Service Bulletin

Subject: Updated Left and Right I/P Fuse Block Labeling

Models: 2014 Chevrolet Silverado 1500

2014 GMC Sierra 1500

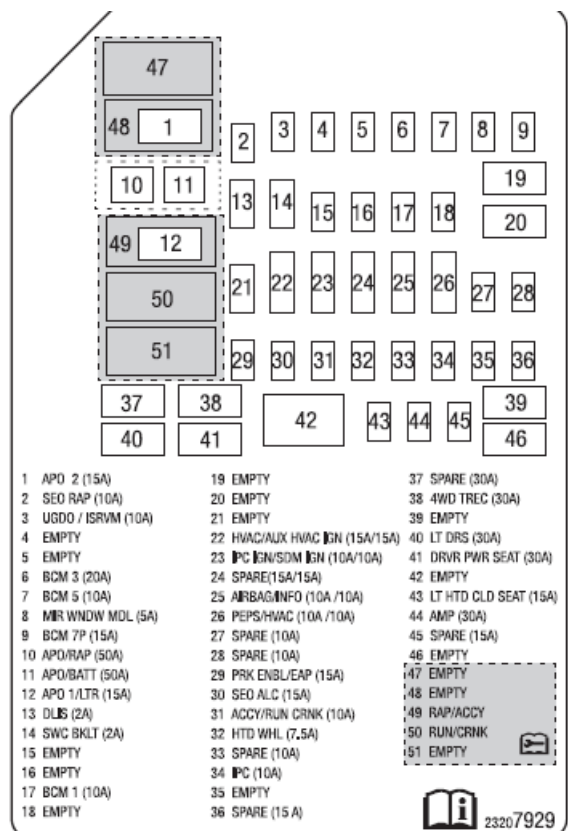
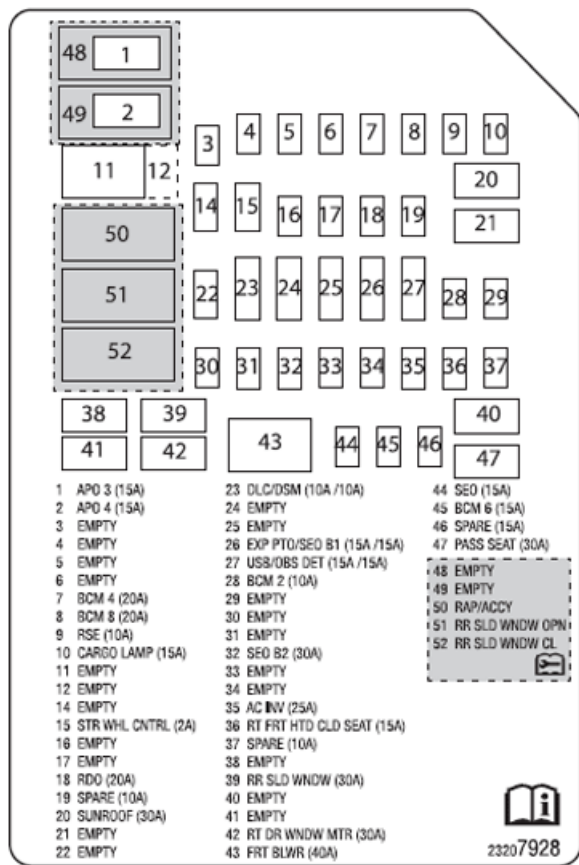
After inspecting the Left and/or Right I/P Fuse Block Labels, it may be noted the numbering is incorrect.

Inspect the lower right corner of each label for P/N 23114670 (Left) and/or P/N 23114671 (Right). If these part numbers are found, replace the label(s) with updated label(s): P/N 23207928 (Right) and P/N 23207929 (Left). See photos below of the updated labels:

Part Number	Description	Qty
23207928	I/P Fuse Block Label (Right)	1
23207929	I/P Fuse Block Label (Left)	1
